To: T10 Technical Committee
From: Rob Elliott, HP (elliott@hp.com)
Date: 17 October 2005
Subject: 05-306r1 SAS-2 STP connection time limits and STP/SMP I_T nexus loss

Suggested changes

Figure 1 — PL_OC (port layer overall control) state machine

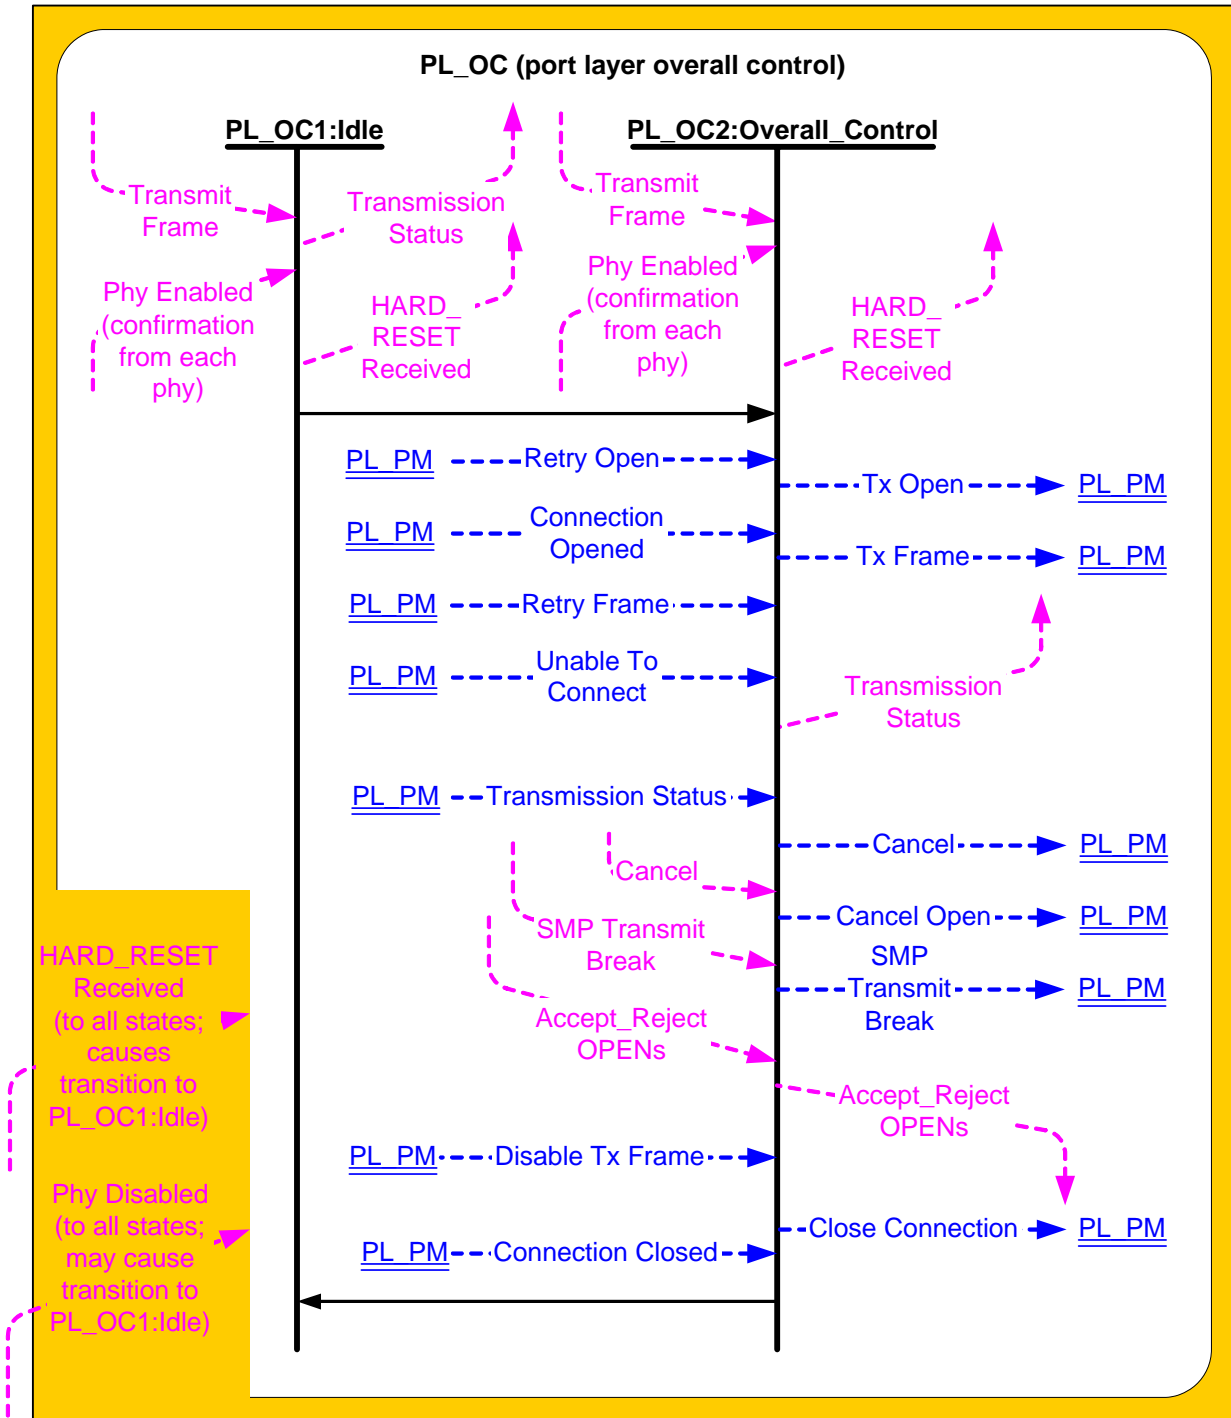
After receiving a Transmit Frame request for a destination SAS address for which there is no connection established and for which no I_T Nexus Loss timer has been created, this state shall create an I_T Nexus Loss timer for that SAS address if:

- ~~a) the protocol is SSP;~~
- ~~b) this state machine is in an SSP target port;~~
- ~~c) the Protocol-Specific Port mode page is implemented by the SSP target port; and~~
- ~~d) the I_T nexus loss time is not 0000h.~~
- a) the protocol is SSP, the port is an SSP target port, the Protocol-Specific Port mode page is implemented, and the I_T NEXUS LOSS TIME field in the Disconnect-Reconnect mode page (see 10.2.7.1) is not set to 0000h;
- b) the protocol is STP, the port is an STP target port, and the STP SMP I_T NEXUS LOSS TIME field in the SMP CONFIGURE GENERAL function is not set to 0000h; or
- c) the protocol is SMP, the port is an SMP initiator port, and the STP SMP I_T NEXUS LOSS TIME field in the SMP CONFIGURE GENERAL function is not set to 0000h.

- a) initialize the I_T Nexus Loss timer as specified in table 1 (see 8.2.2.1); and
 b) not start the I_T Nexus Loss timer.

Editor's Note 3: moved the When... paragraph down a few paragraphs from its current location

Figure 2 — PL_PM (port layer phy manager) state machine (part 1)

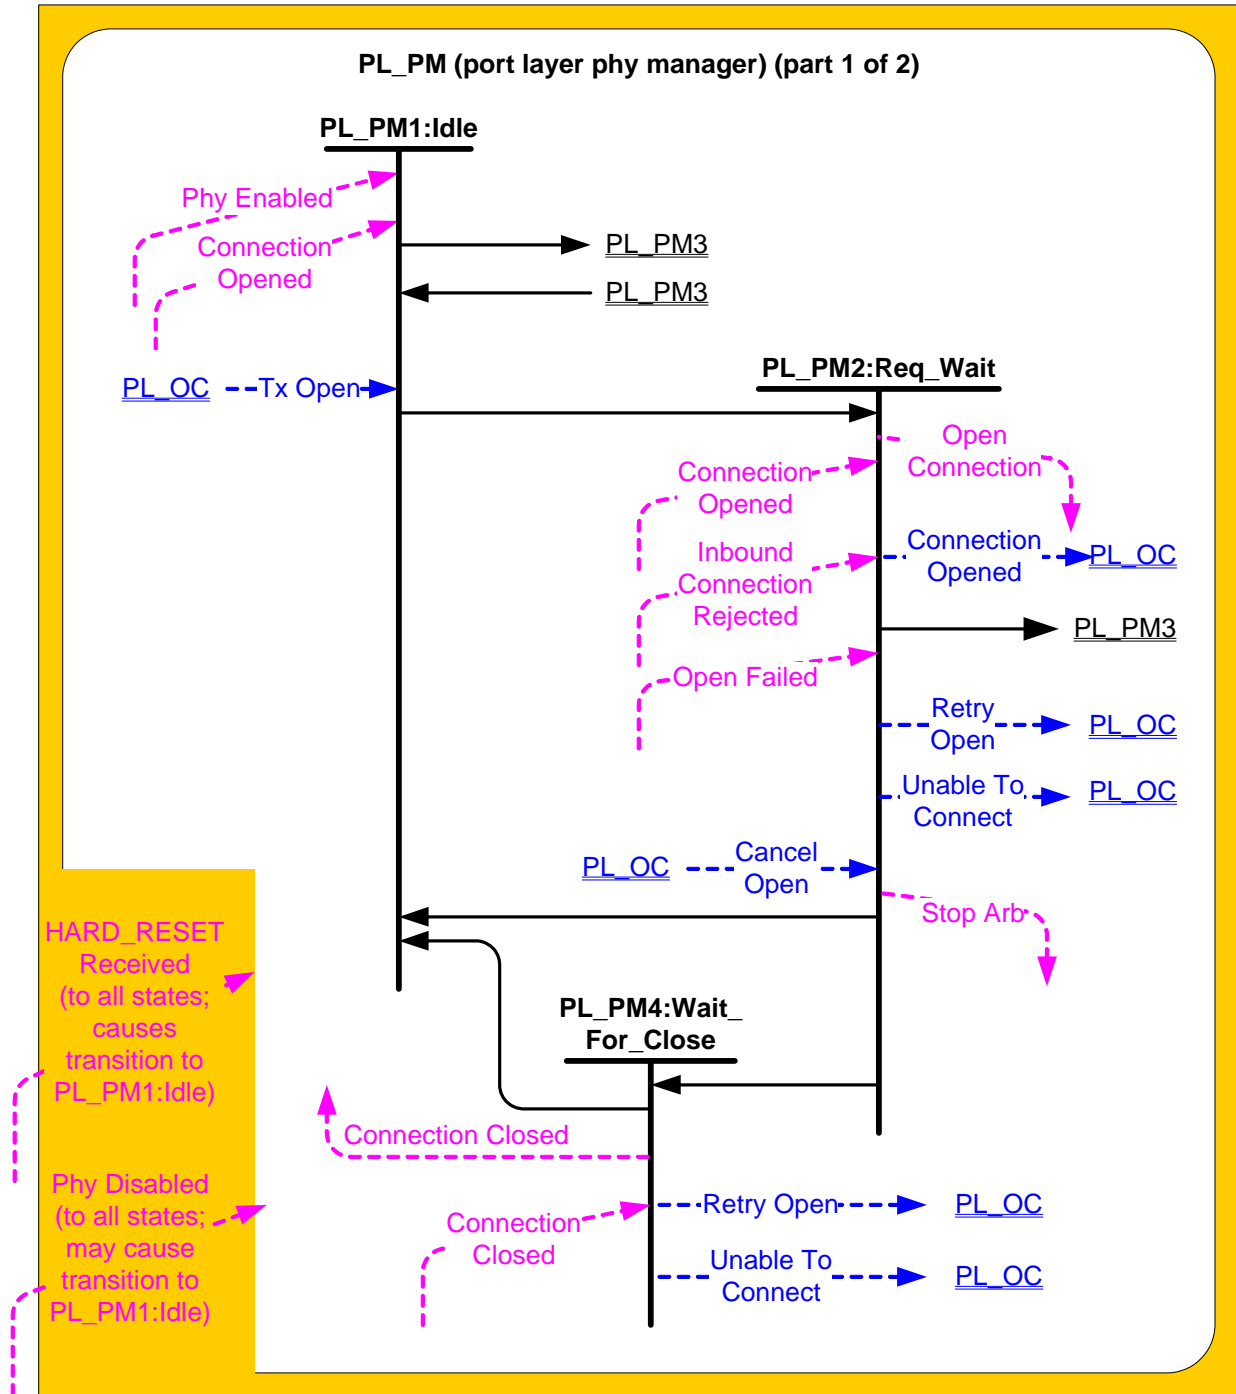
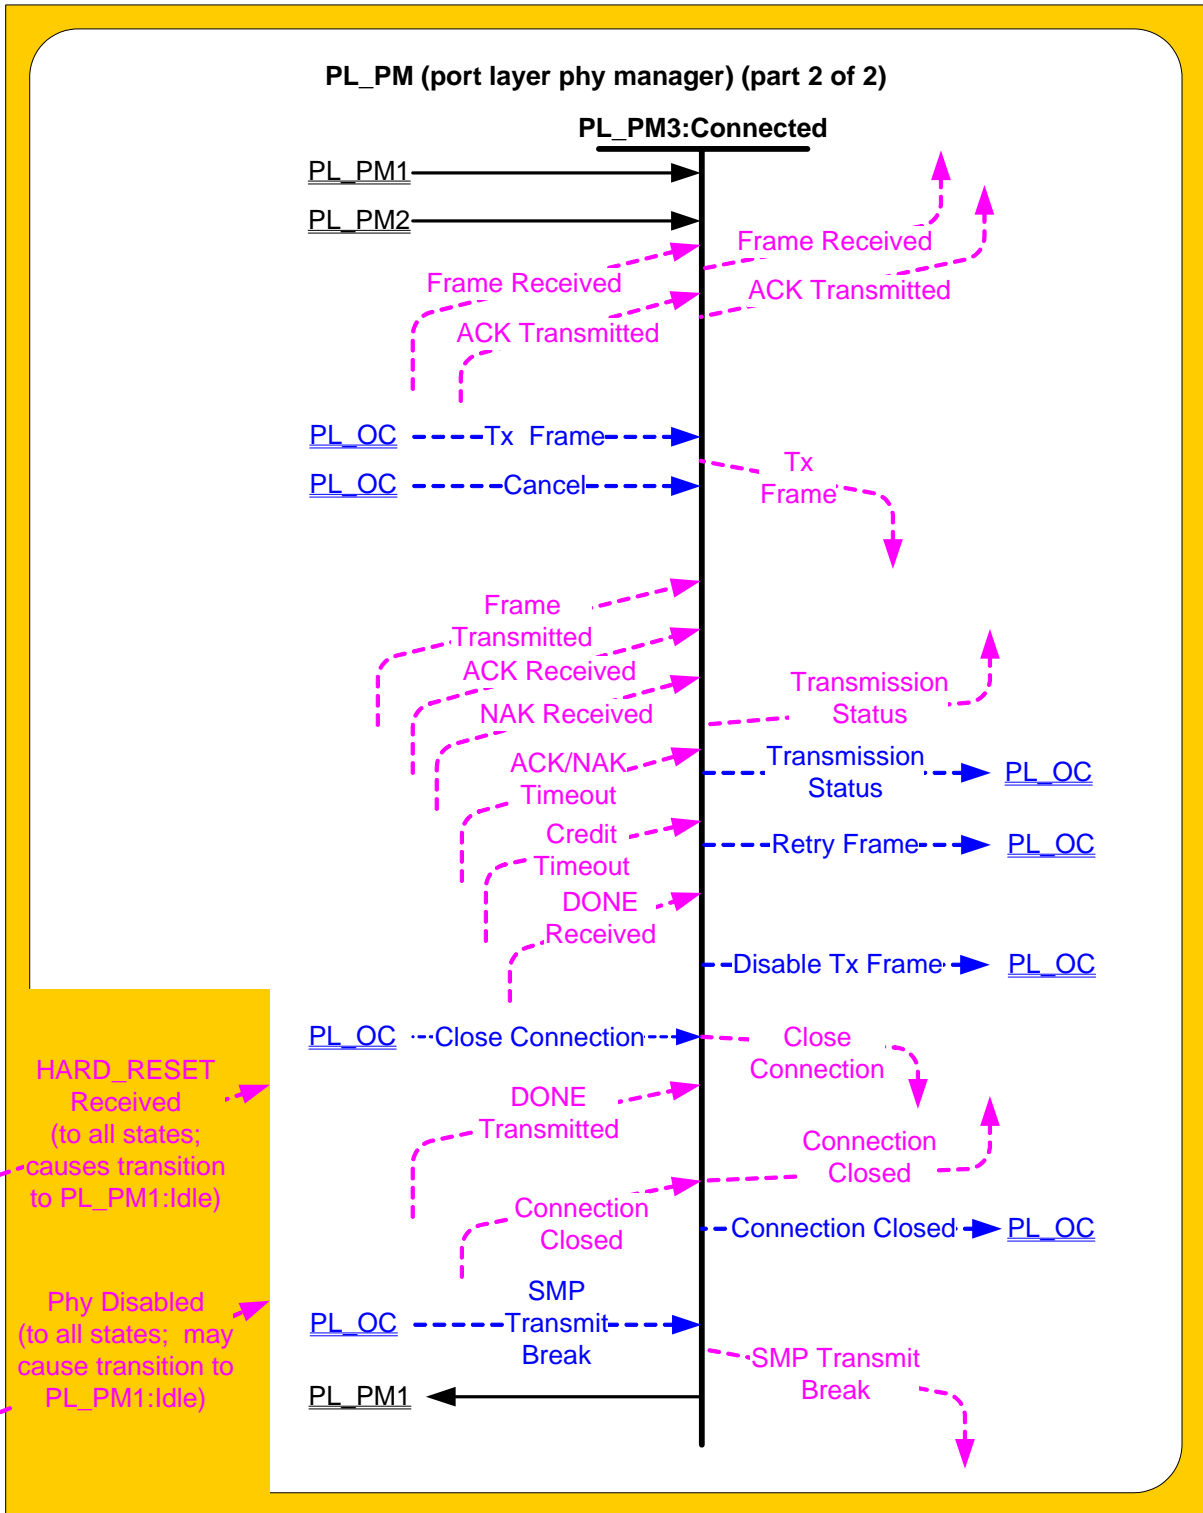
Timer	Initial value
Arbitration Wait Time timer	The arbitration wait time argument from a Retry Open message (see 8.2.2.3.1).
Bus Inactivity Time Limit timer	<p><u>Depending on the protocol used by the port:</u></p> <p>a) <u>for SSP target ports, the value in the BUS INACTIVITY TIME LIMIT field in the Disconnect-Reconnect mode page; or</u></p> <p>b) <u>for STP target ports, the value in the STP BUS INACTIVITY TIME LIMIT field in the SMP REPORT GENERAL function.</u></p>
Maximum Connect Time Limit timer	<p><u>Depending on the protocol used by the port:</u></p> <p>a) <u>for SSP target ports, the value in the MAXIMUM CONNECT TIME LIMIT field in the Disconnect-Reconnect mode page (see 10.2.7.1); or</u></p> <p>b) <u>for STP target ports, the value in the STP MAXIMUM CONNECT TIME LIMIT field in the SMP REPORT GENERAL function.</u></p>
